CHANGE ORDER PROPOSAL: 064

Woodland High School

PROPOSED CONTRACT MODIFICATION:

ASK-156

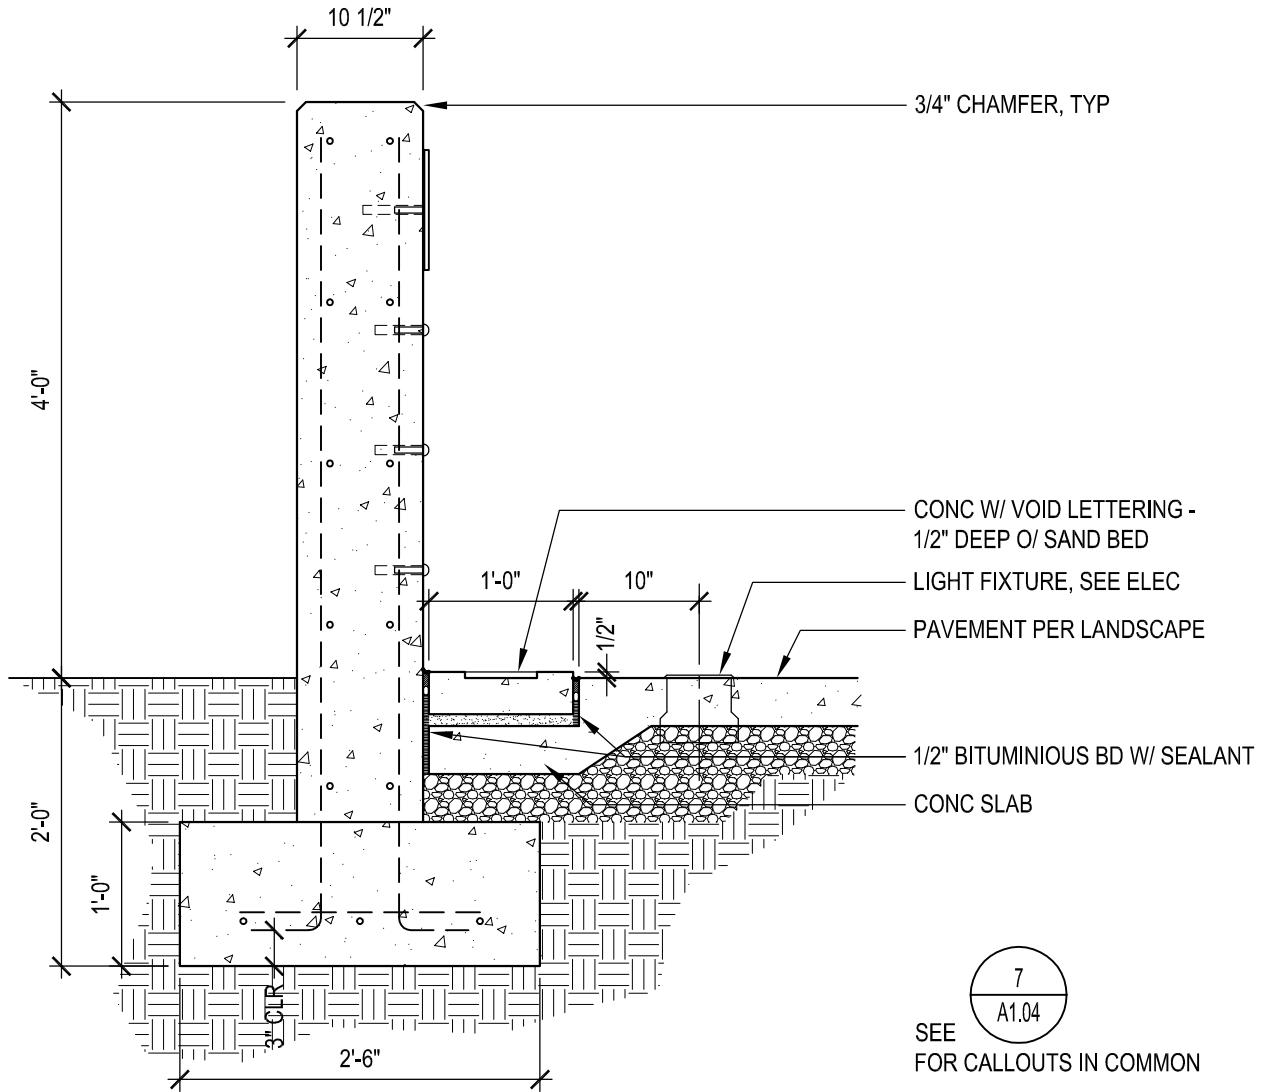
- Provide the "Wall of Tribute" per the attached drawings and details.
- Include the "legend" plaque and the type C and D plaques shown on ASK-159. Plaques are 1/4" thick stainless steel with a beveled perimeter edge and etched letters painted black. Finish is #4 brushed.
- Provide in grade light fixtures as shown in the attached sketches (ASK-156 through ASK-159). Fixtures shall be by Kim #LTV768WF/9L4KUV TR60. Splice and extend existing exterior site lighting circuit 1H01-39 from adjacent AL1 fixture.
- Revise irrigation per LSK-XXX
